Subject: RAI Response Clarifications
R.E. Ginna Nuclear Power Plant
Docket No. 50-244

Attachment 1

Clarifications

**DA-CE-2002-016-07, Containment Time Limited AgIn Analyses for
License Renewal: Tendon Bellows Fatigue**

FIG. N-415(B) ALLOWABLE AMPLITUDE OF ALTERNATING STRESS INTENSITY, S_a , FOR 18-8 STAINLESS STEELS AND NICKEL-IRON CHROMIUM ALLOY (FOR METAL TEMPERATURES NOT EXCEEDING 800 F).

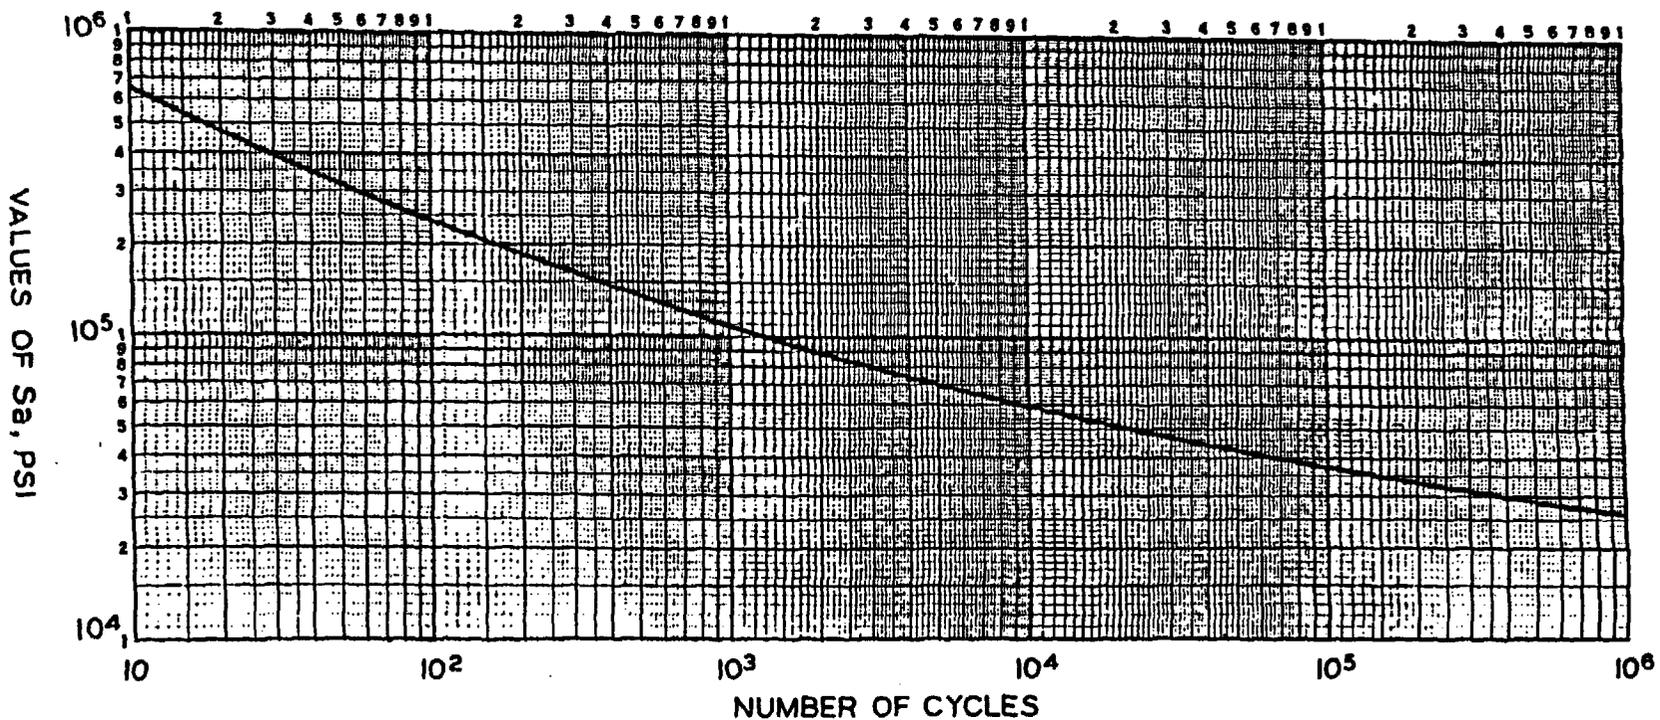
The applicant is requested to provide the bases for (1) 0.030 in (vertical), (2) 0.0014 (radial) displacements, and (3) 144 cycles used in the final fatigue usage factor calculations.

From ASME Code Figure N-415(B) for stainless steel (Attachment 4), the allowable alternating stress amplitude, S_a , for 80 cycles is 260 ksi. Assume that this is the peak stress produced in the bellows due to the combined effect of design basis vertical and radial displacements of 0.10" and 0.16" given in UFSAR Figure 3.8-18 (Attachment 1), and that this stress is directly proportional to the absolute sum of the displacements. Thus, $S_a = 260$ ksi is produced at an absolute displacement of 0.26".

The alternating stress intensity amplitude of 44 ksi corresponds to 40,000 cycles. The fatigue usage factor is $144/40,000 = 0.004$.
